Mt. Juliet, Tennessee

Planning Commission

Agenda

Thursday, July 18, 2024

Exhibit C- PMDP and Rezone

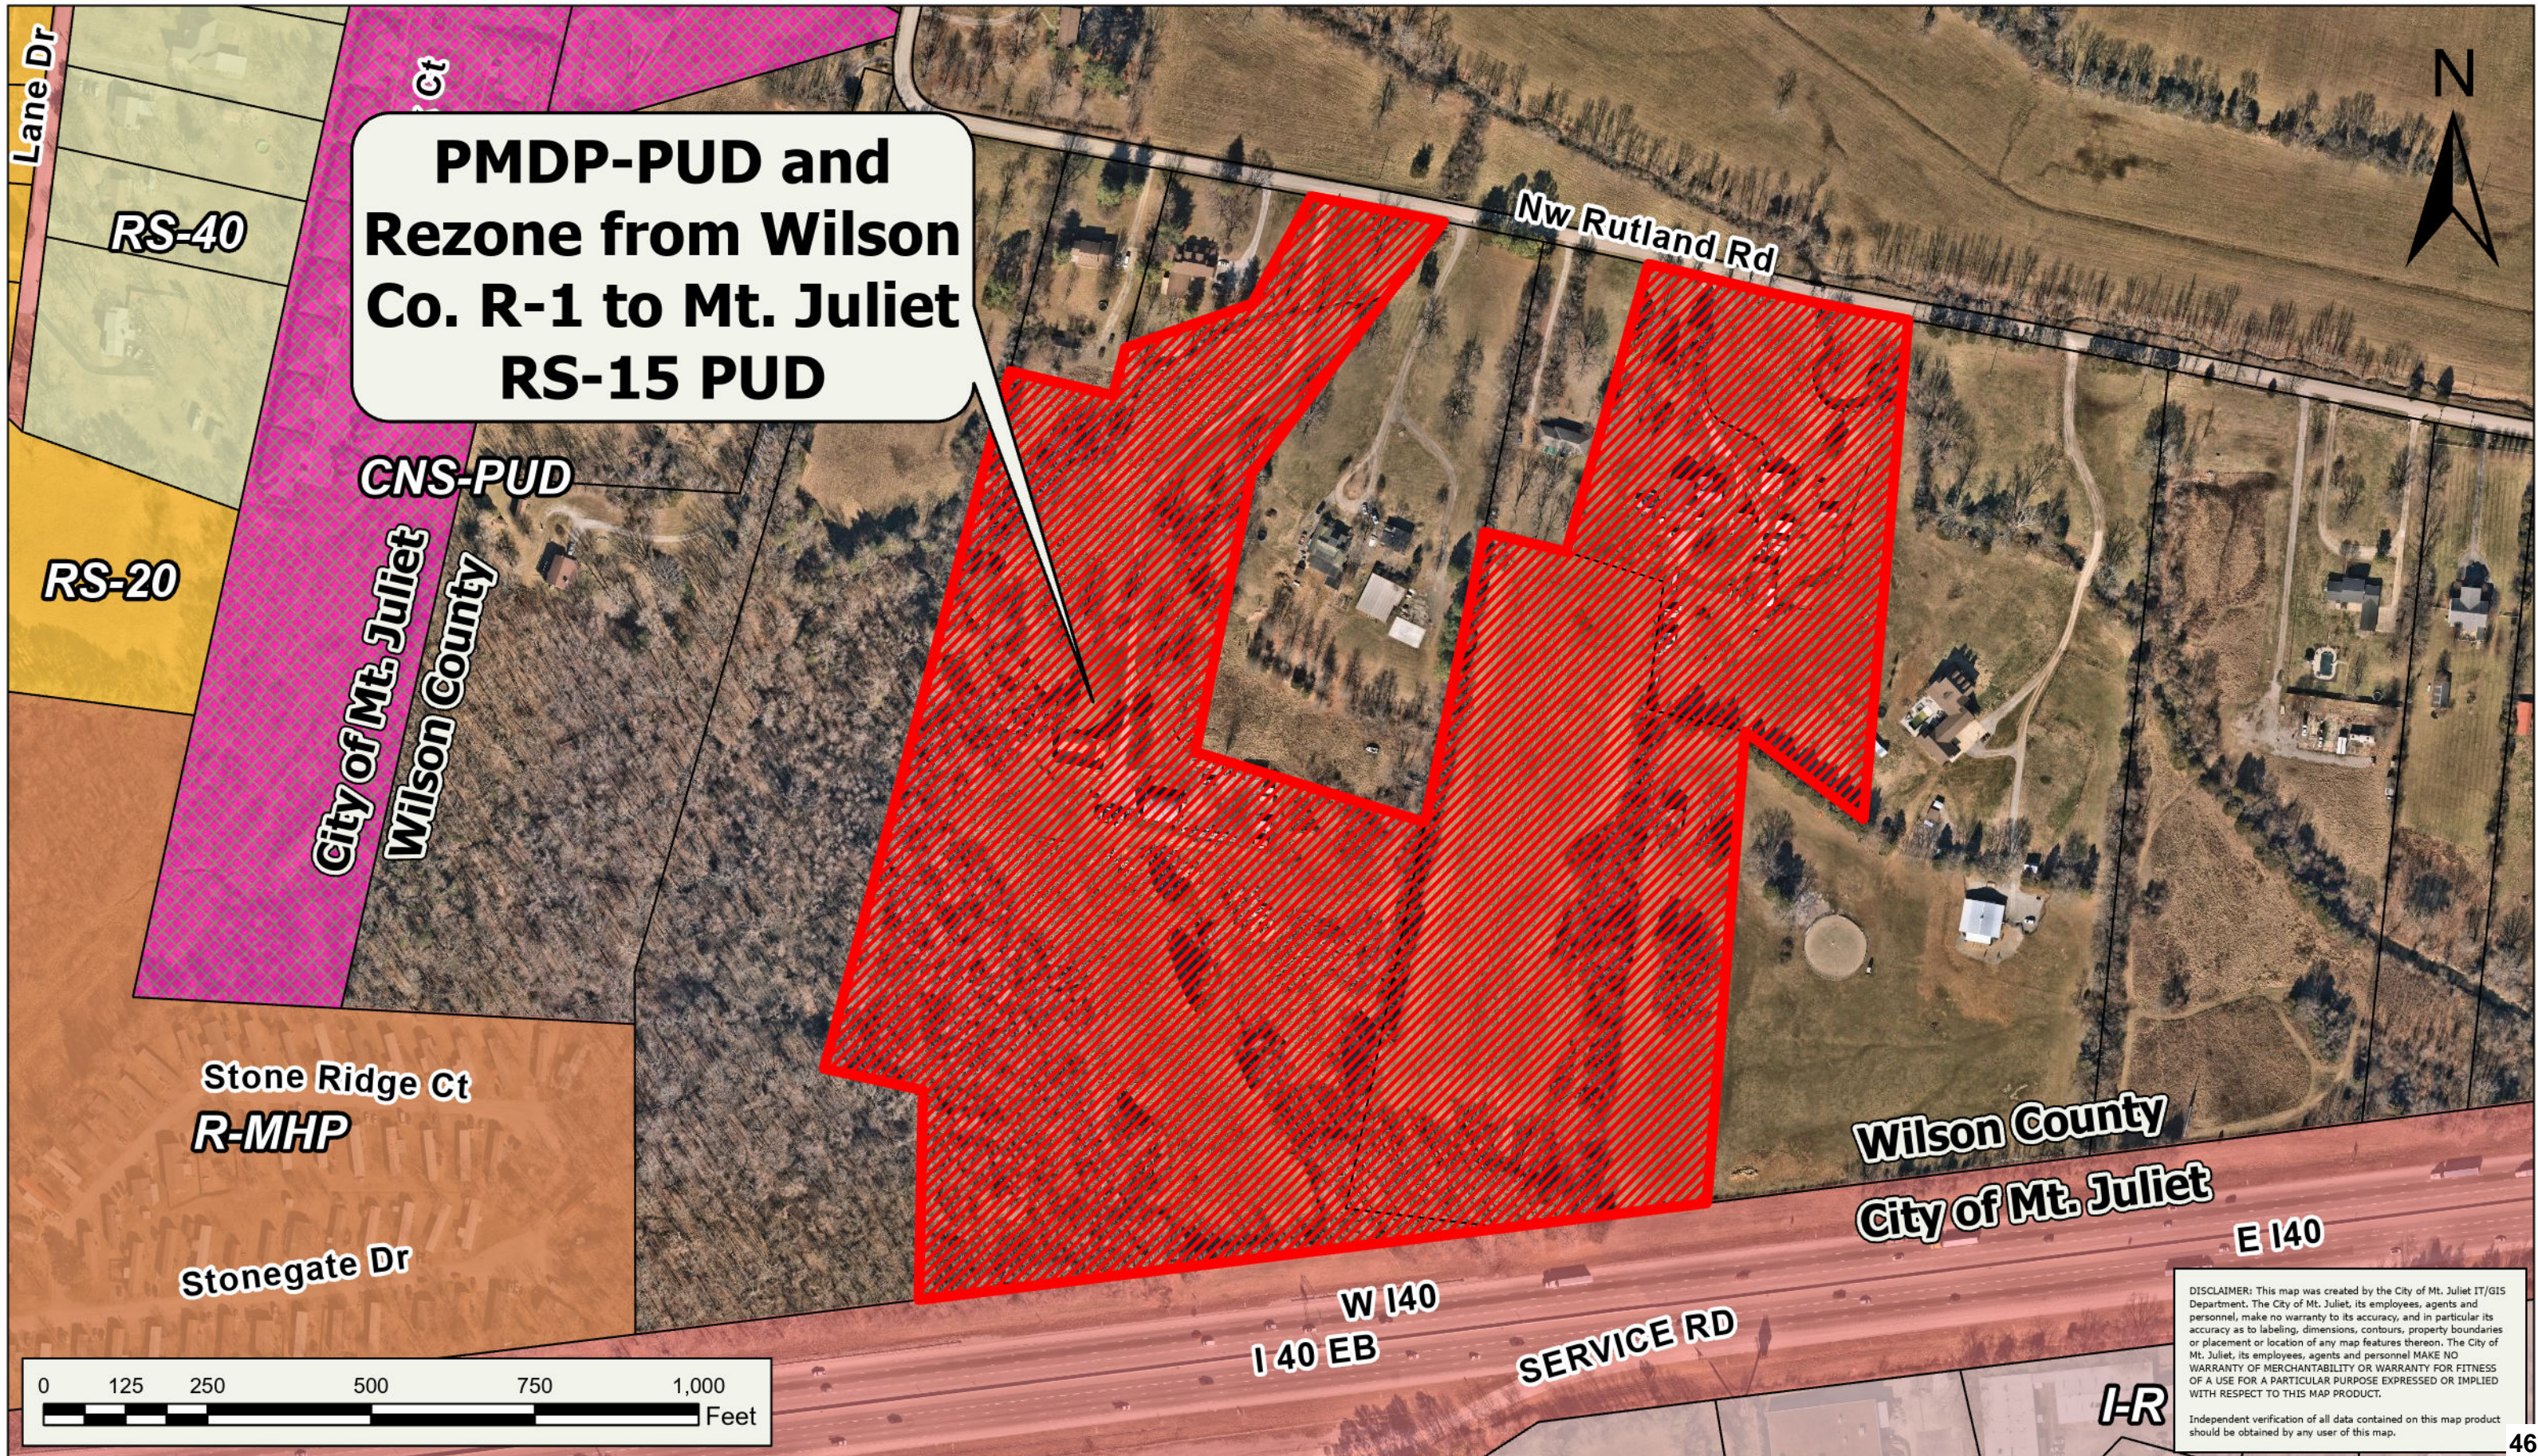
1. Remove amenities and walking trails from the landscape buffer and detention areas on the west side of the site.
2. Add a note that all landscaping buffers and open space is to be maintained by the HOA.

3. Landscape buffers shall be located in open space and not on individual lots.
4. Provide a 6' tall opaque, low maintenance material fence on the inside edge of all landscape buffers.

5. Provide bicycle parking at the amenity center.
6. Wet ponds shall include lighted fountains.
7. Provide landscaping and a decorative, low maintenance fence with lockable gate around all detention/retention ponds.

11. Provide an estimated development timeline.
12. Preserve as many trees as possible.
13. Provide decorative streetlighting throughout the PUD and at the entrances. These fixtures shall be maintained by the HOA.

22. Provide individual garage doors separated by a brick column where two car garages are provided per 5-104.4, unless the waiver request is granted.
23. Garages shall be recessed 10' unless the waiver request is granted.

1. All wet ponds, if proposed, shall have aeration.
2. Provide steep slope sheets.
3. All sanitary sewer shall be public and within a minimum 20' sewer easement.
4. No homes shall be served for sewer via individual grinder pumps or onsite step or septic systems.
5. All improvements to NW Rutland Road are subject to review and approval of the Wilson County Road Commission. The developer shall provide correspondence from the Wilson

6. A letter of approval from West Wilson Utility District will be needed prior to construction plan approval is issued.
7. The turnaround on Road E shall have an entering radius of 50'.

- a. The revised plans show a turnaround radius of 50' but the entrance radius still looks substandard. Consult ST-121 for cul-de-sac dimensions.
8. Landscaping plans shall be approved prior to construction plans approval.

13. ADA compliant curb ramps are required on the corners of all intersections.
14. There are two layers showing lot ownership. Please remove one layer.
15. Staff does not support requested variance #2 for front loading garages from an access street. Units may be side loaded.

1. Water lines shown are not WWUD's design.
